CITY OF MOUNTAIN VIEW

STAFF REPORT

FEBRUARY 15, 2017

5.1 Study Session to Discuss Proposed General Plan and Zoning Map Amendments to allow a Residential Development Consisting of Two New Seven-Story Residential Structures with a Total of 303 Units and an Above-Grade Parking Structure on a Site with a 111,443 Square Foot Office Building at 1001 North Shoreline Boulevard

Heritage Tree Diagram

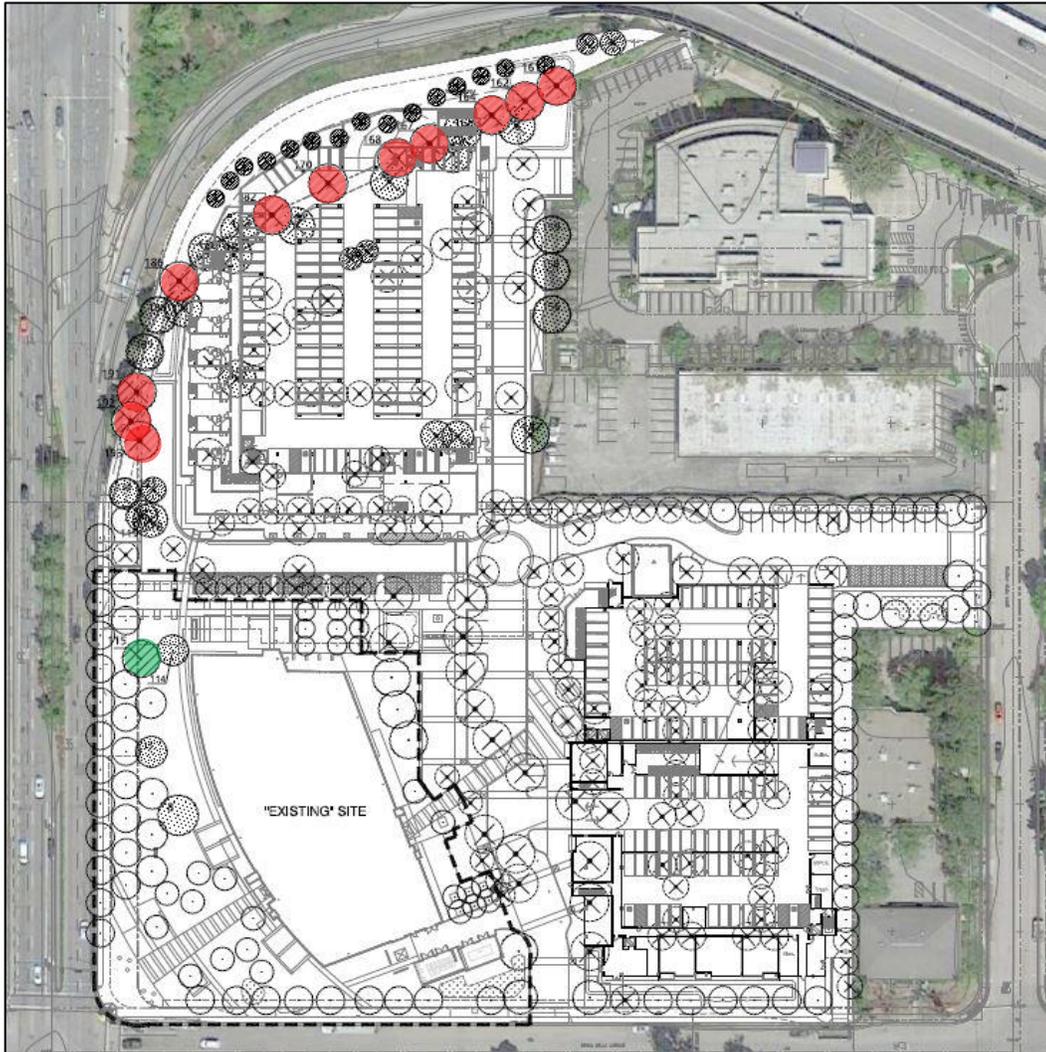
The office project was approved with the removal of 33 Heritage trees. To accommodate the proposed residential structures, 11 out of the 12 remaining healthy Heritage trees are proposed for removal. These trees are primarily located at the north end of the property and toward the edge of the proposed apartment building footprint. Staff recommends the applicant study modifications to the proposed apartment building to allow additional Heritage trees to be preserved or relocated on-site.

A total of 259 trees will be planted as part of the approved office project, primarily in the surface parking lot. Through construction of the residential structures, 152 of these trees are proposed for removal. Staff recommends that a priority be placed on retention and relocation of the office trees on-site.

Question 6: Should modifications to the apartment structure be required in order to retain additional Heritage trees on-site? Should the office trees be relocated on-site to the best extent possible?
